RE: Safety-Kleen Corp.--Medley, Florida Facility

Subject: Proposed Medley Service Center  
Construction Permit #HC 13-175466

**SAFETY-KLEEN CORP.  
MEDLEY SERVICE CENTER  
RESPONSES TO COMMENTS DATED MARCH 26, 1990**

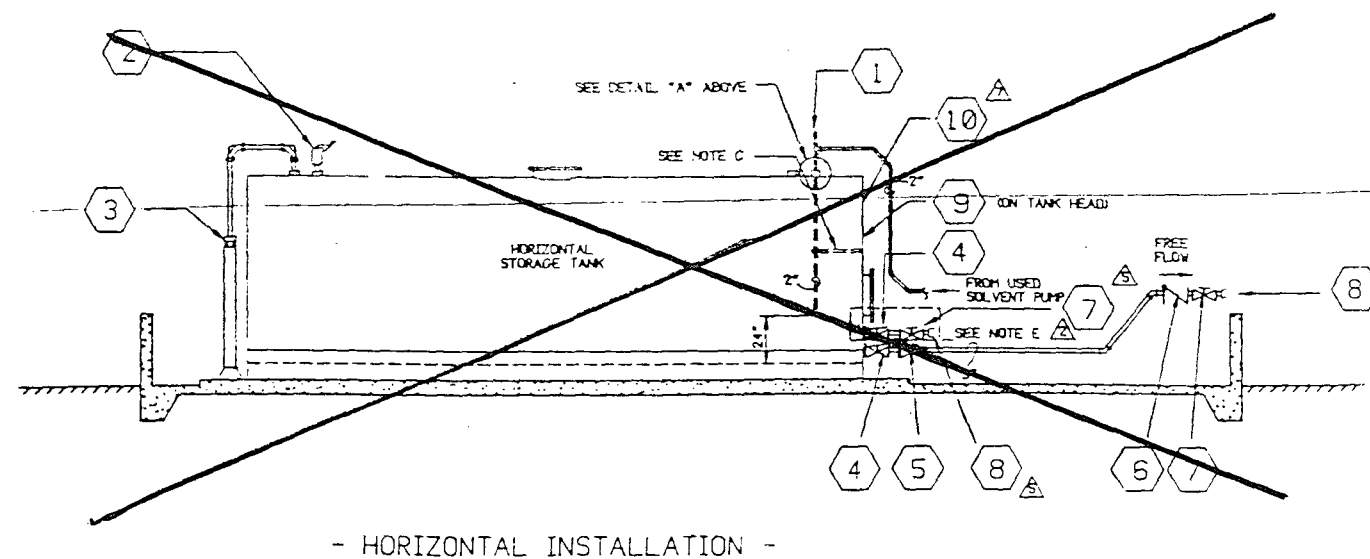
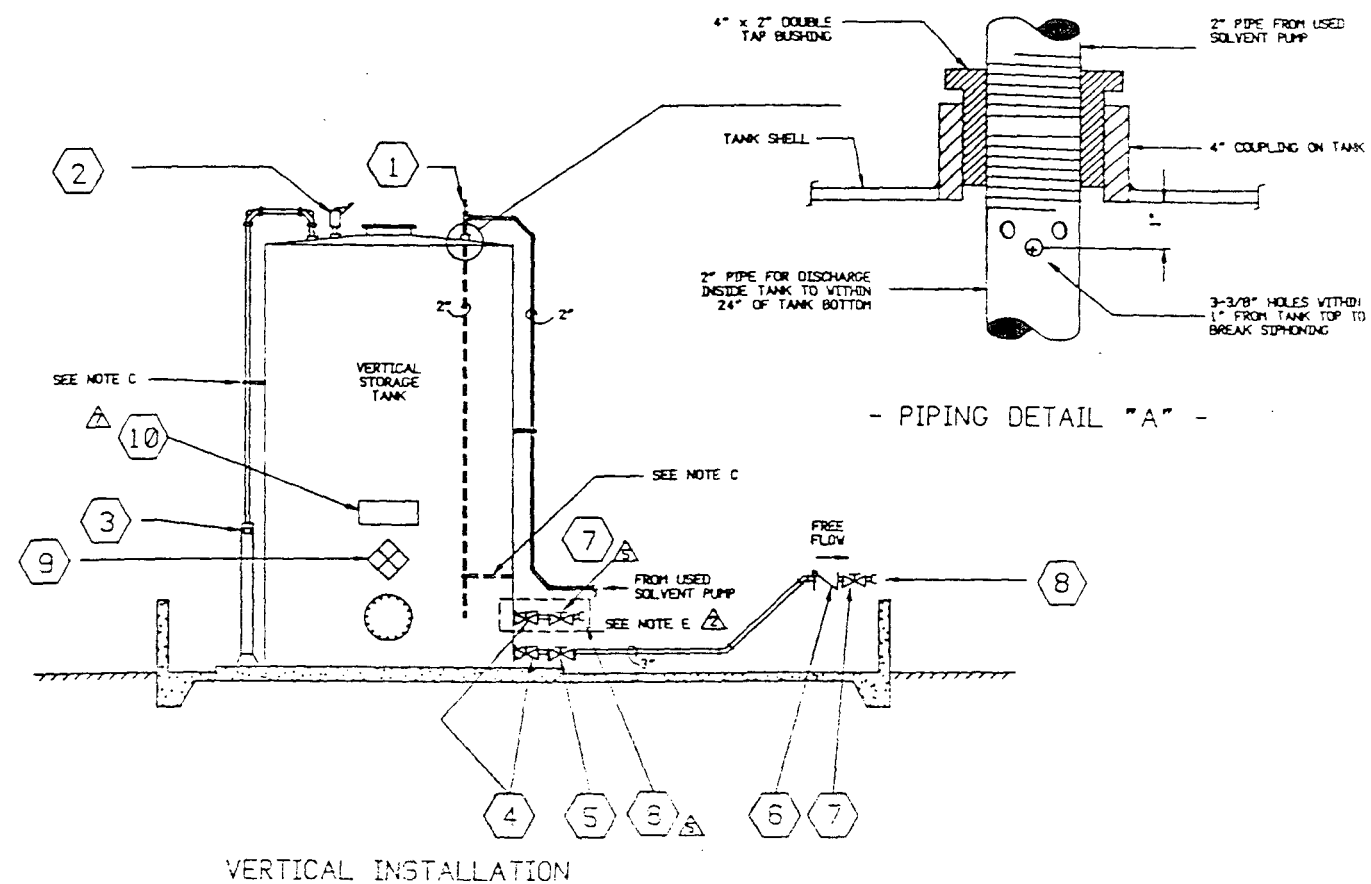
16. 4. Exhibit I.E. 3-7 does not detail which couplings will be used for drain line connection, vent line connection, fill line connection and high level alarm transmitter. Provide a drawing which supplies this information.

Drawing D11150 Solvent Pump Piping Installation Details is enclosed.

# SKETCH OF SURVEY

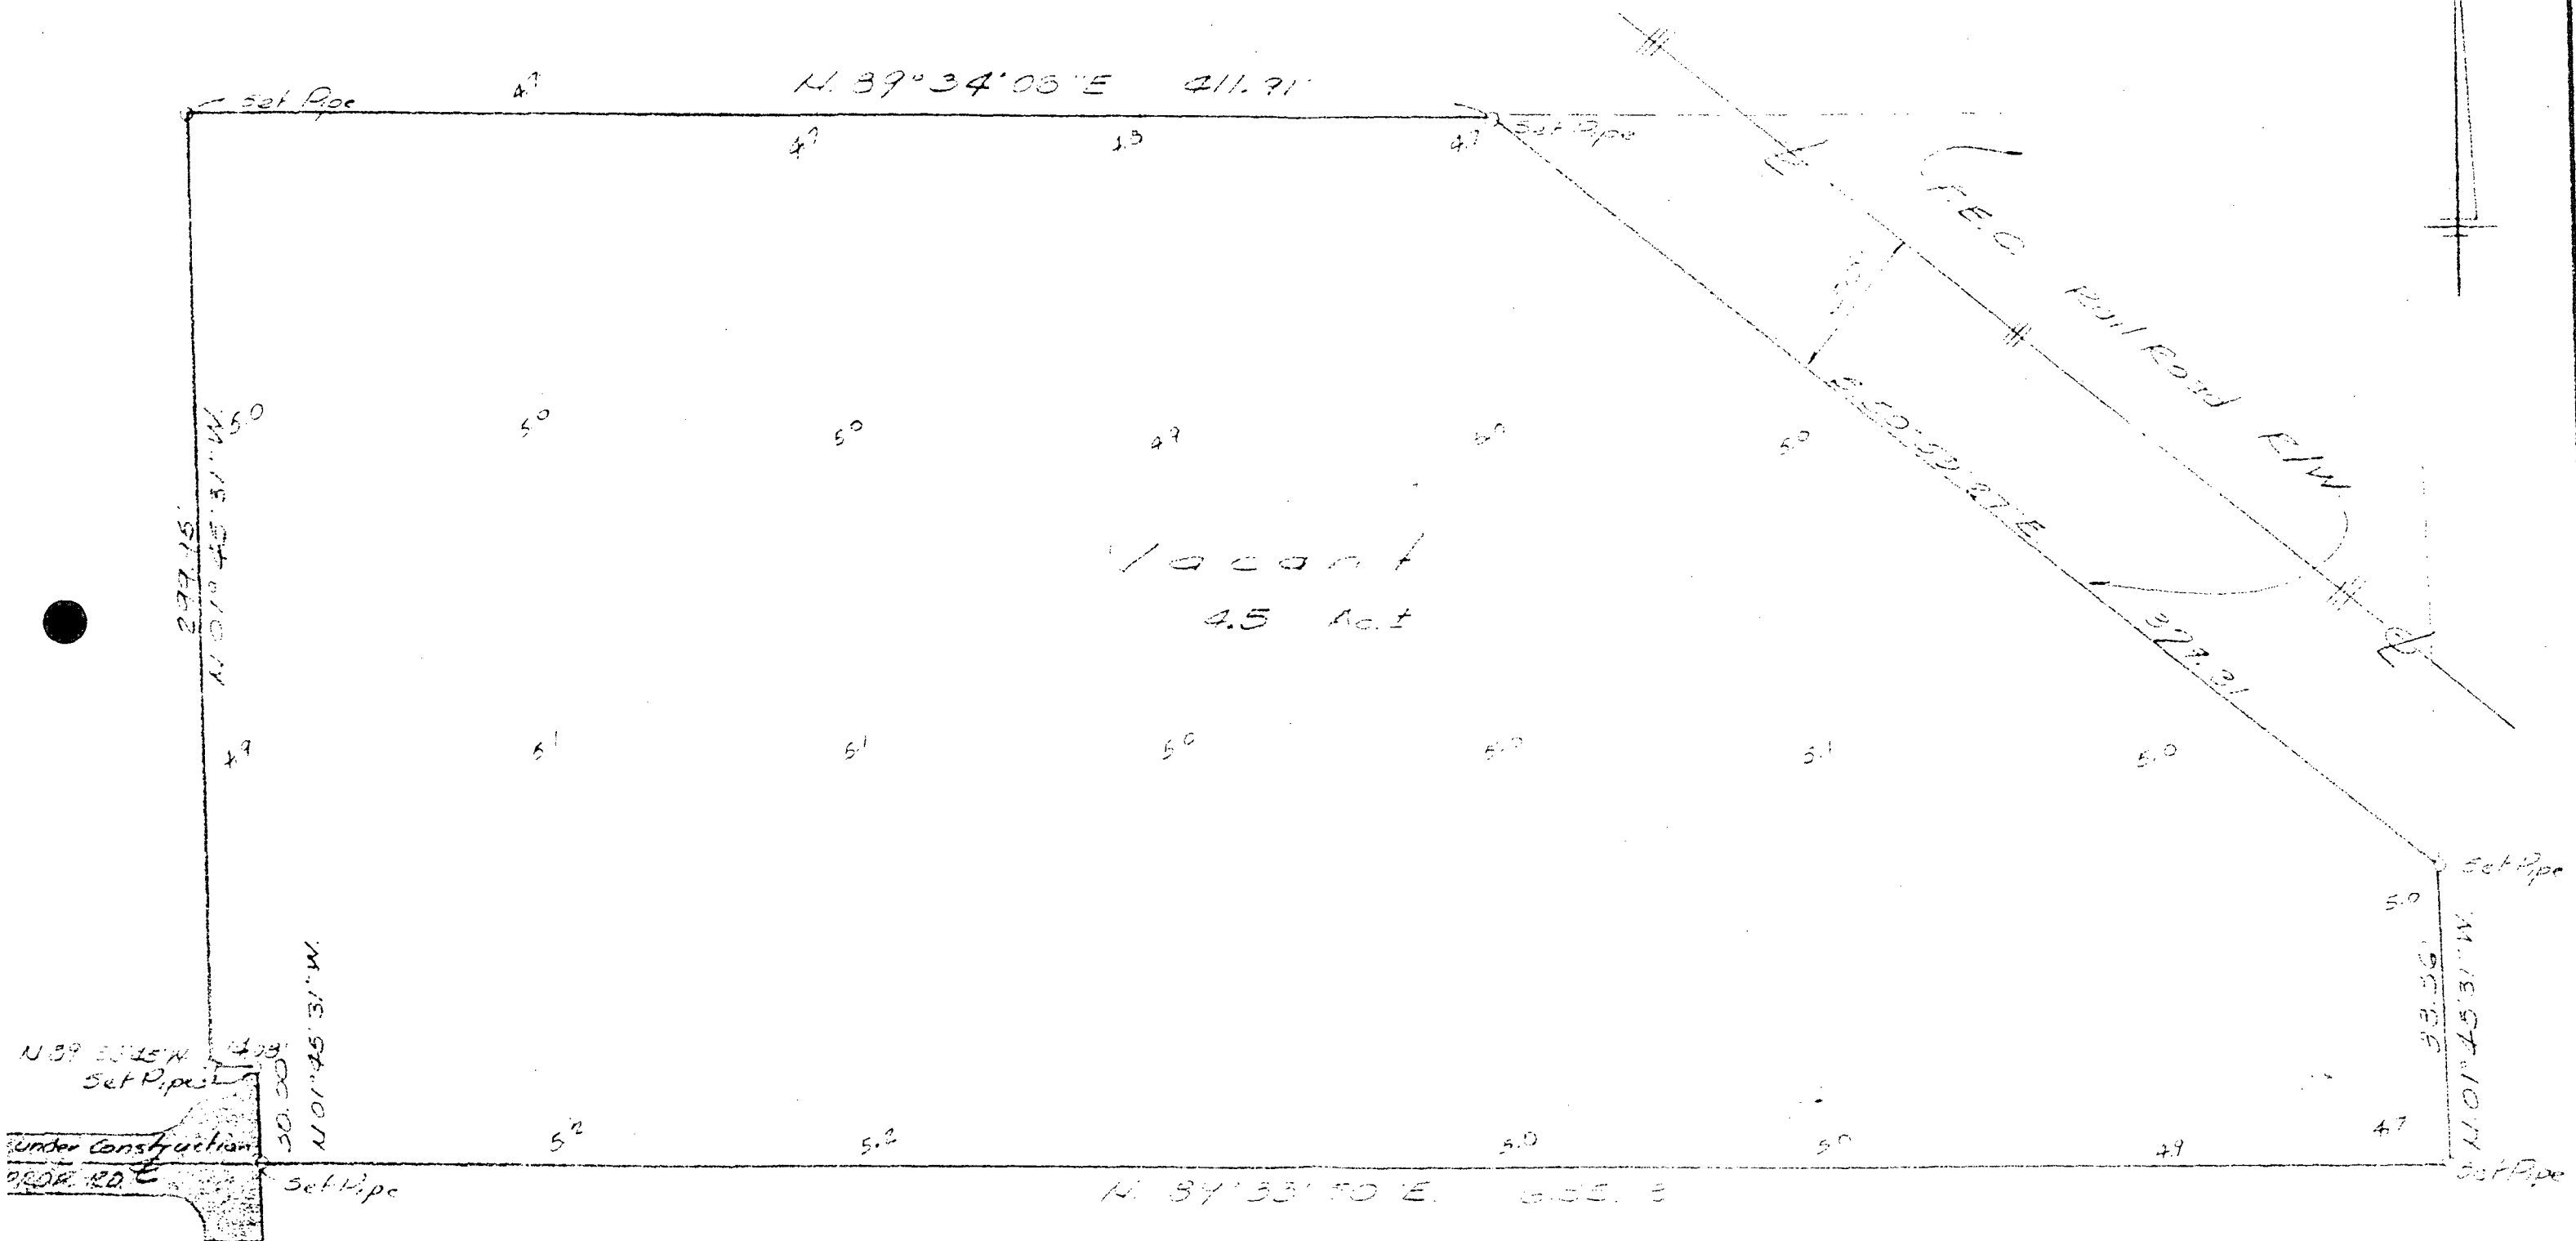
4. 1A. The maps provided in the application do not adequately depict the area of 100-year floodplain (illegible), orientation of the topographic map, contours sufficient to show surface water flow, drainage or flood control and runoff control system. Submit a map or series of maps (legible quality) which clearly detail the inadequately depicted site characteristics.

Please see response to comment #3. In addition, a site survey drawing with spot elevations indicating the direction of surface water flow is enclosed.
